TITEL: Installation av avstängningsklämma i extra bränsletankens dräneringssystem

GÄLLER: R44 S/N 0002 t o m 0529 undantaget 0440, 0485, 0512, 0515, 0519, 0526, 0527 och 0528

99-13-11 ROBINSON HELICOPTER COMPANY: Amendment 39-11204. Docket No. 98-SW-71-AD.

FIGURE 1
AD 99-13-11

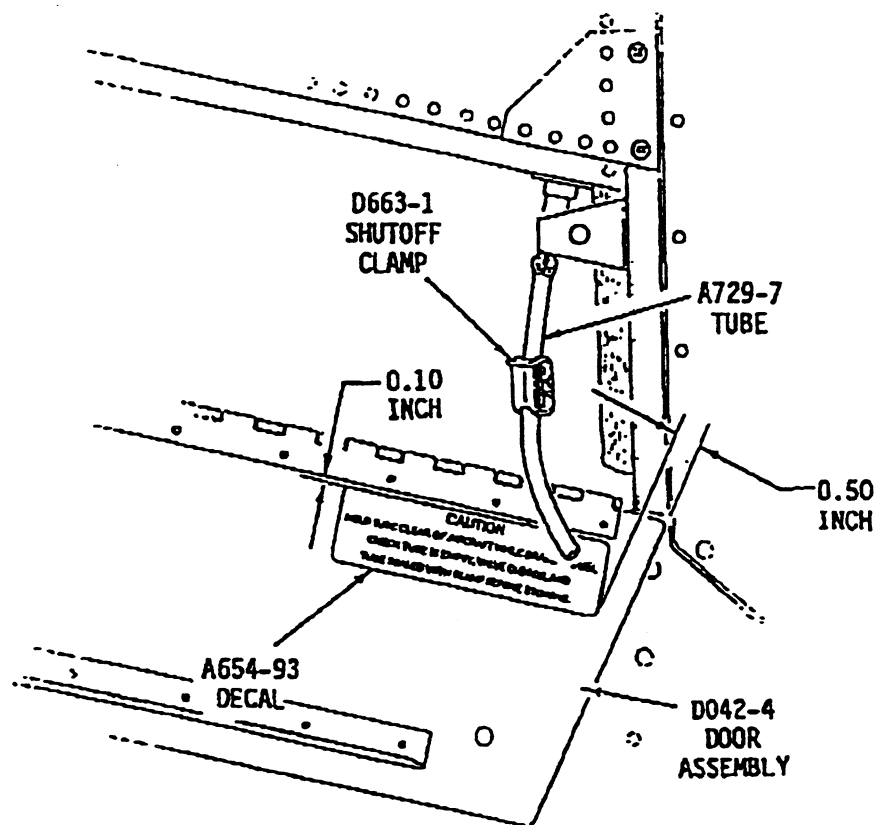
To prevent fuel leaks from the auxiliary fuel tank sump drain, which could cause a fire and subsequent loss of control of the helicopter, accomplish the following:

- (a) Install a shutoff clamp, part number (P/N) D663-1, by sliding it onto the auxiliary fuel tank sump drain tube, P/N A729-7, as shown in Figure 1.
- (b) Install placard decal, P/N A654-93, as shown in Figure 1.
- (c) An alternative method of compliance or adjustment of the compliance time that provides an acceptable level of safety may be used if approved by the Manager, Los Angeles Aircraft Certification Office. Operators shall submit their requests through an FAA Principal Maintenance Inspector, who may concur or comment and then send it to the Manager, Los Angeles Aircraft Certification Office.
